**ADDENDUM NO. 2**

**MIDWESTERN STATE UNIVERSITY**  
**MOFFETT LIBRARY RENOVATION**  
**PHASE I**

Addendum Date: 17 April 2018

I-001

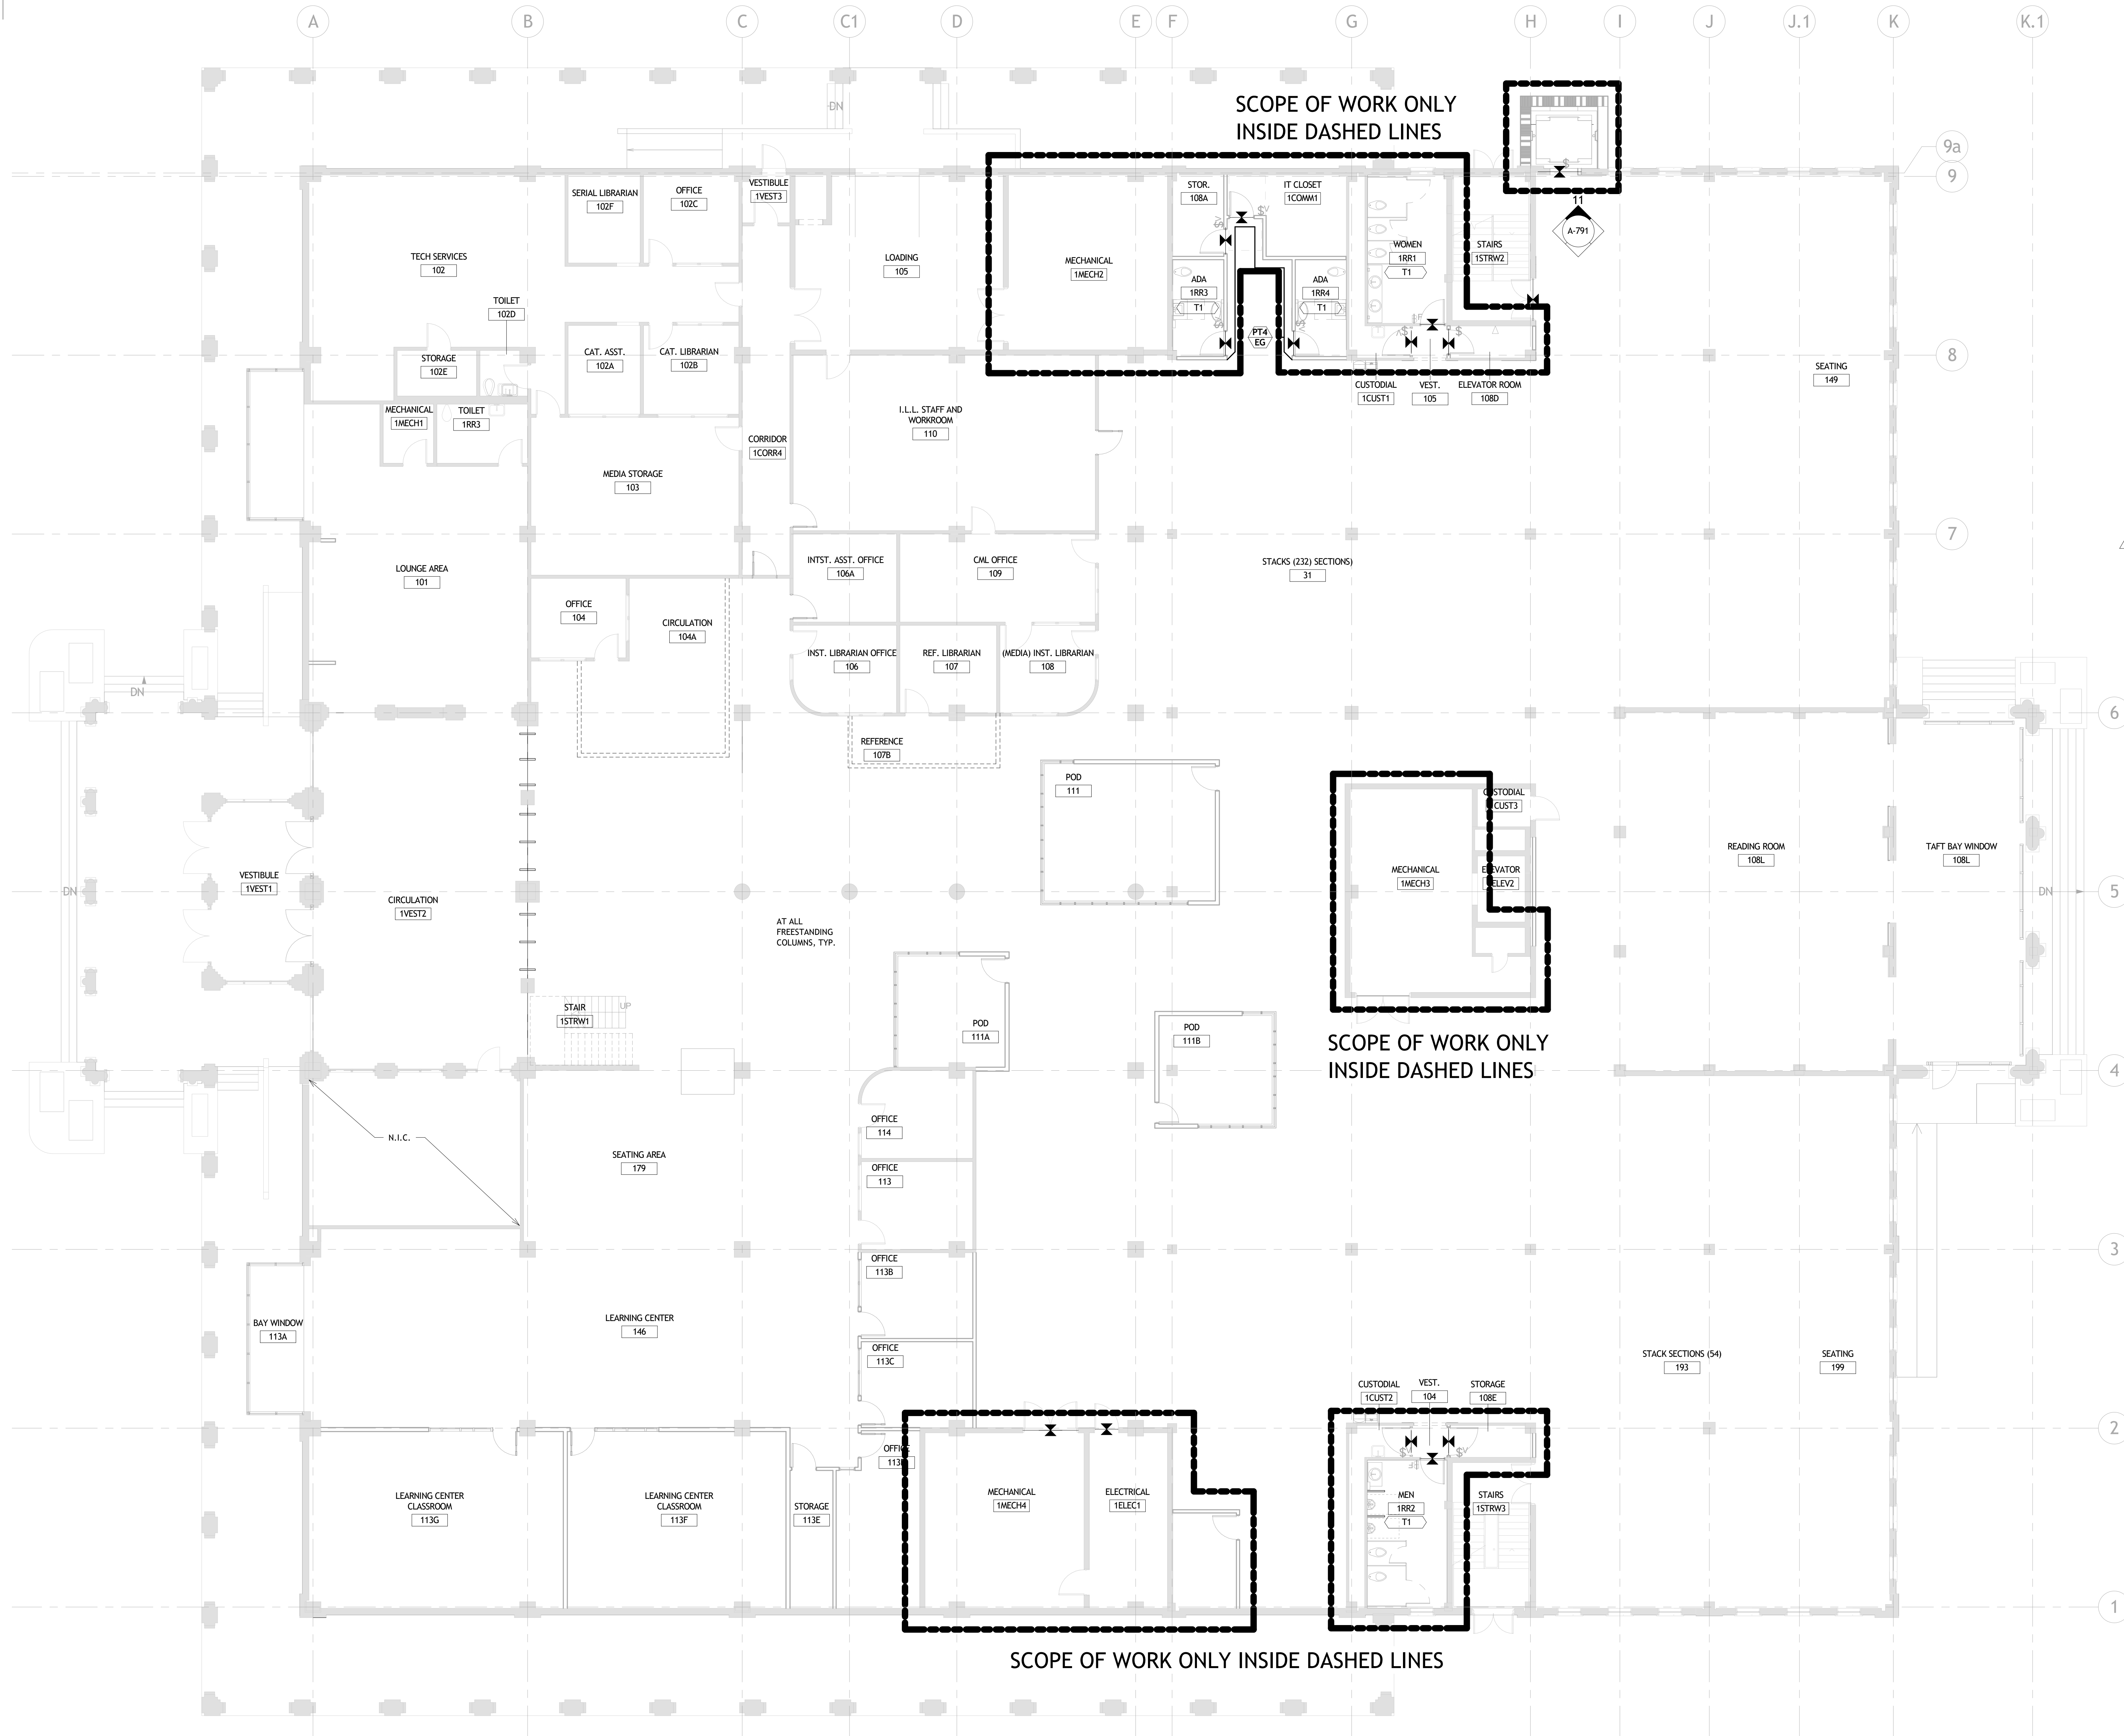
Replace the Drawings with the revised Sheets attached in this Addendum. Revisions have been made to the "ROOM FINISH SCHEDULE" and the "FLOORING FINISH PLANS" concerning the provision of temporary carpet flooring in Vestibules leading to Men's and Women's Toilet areas.

1	FIRST FLOOR	1CUST1	CUSTODIAL	Existing	Existing	Existing	Existing	Existing	Existing	Exposed	
1	FIRST FLOOR	108D	ELEVATOR ROOM	BBT1	Existing	PT1	PT1	PT1	PT1	Existing	EXISTING FLOOR TILE TO BE REMOVED. EXISTING WALL TILE TO REMAIN.
1	FIRST FLOOR	1COMM1	IT CLOSET	SEE FINISH NOTES	RB1	PT1	PT1	PT1	PT1	Exposed	EXISTING CARPET TO BE REMOVED. EXPOSED CONCRETE TO BE PATCHED & REPAIRED AS NEEDED.
1	FIRST FLOOR	1RR3	ADA	T1	TB1	PT4/CT3	PT4/CT3	PT4/CT3	PT4/CT3	ACT1B	SEE SHEET A-731 FOR FINISH DETAILS
1	FIRST FLOOR	1RR4	ADA	T1	TB1	PT4/CT3	PT4/CT3	PT4/CT3	PT4/CT3	ACT1B	SEE SHEET A-731 FOR FINISH DETAILS
1	FIRST FLOOR	104	VEST.	CPT2	RB1		PT4	PT4	PT4	ACT1	PROVIDE TEMPORARY CARPET FLOORING FOR PHASE I WORK. SELECTED CARPET TO BE INSTALLED DURING PHASE II WORK
1	FIRST FLOOR	105	VEST.	CPT2	RB1		PT4	PT4	PT4	ACT1	PROVIDE TEMPORARY CARPET FLOORING FOR PHASE I WORK. SELECTED CARPET TO BE INSTALLED DURING PHASE II WORK

1	THIRD FLOOR	311A	STORAGE	BBT1	Existing	PT1	PT1	PT1	PT1	Existing	EXISTING FLOOR TILE TO BE REMOVED. EXISTING WALL TILE TO REMAIN.
1	THIRD FLOOR	3COMM1	IT CLOSET	SEE FINISH NOTES	RB1	PT1	PT1	PT1	PT1	Exposed	EXISTING CARPET TO BE REMOVED. EXPOSED CONCRETE TO BE PATCHED & REPAIRED AS NEEDED.
1	THIRD FLOOR	347	VEST.	CPT2	RB1		PT4	SEE FINISH PLANS	PT4	ACT1	PROVIDE TEMPORARY CARPET FLOORING FOR PHASE I WORK. SELECTED CARPET TO BE INSTALLED DURING PHASE II WORK
1	THIRD FLOOR	307H	VEST.	CPT2	RB1	PT4	PT4		PT4	ACT1	PROVIDE TEMPORARY CARPET FLOORING FOR PHASE I WORK. SELECTED CARPET TO BE INSTALLED DURING PHASE II WORK
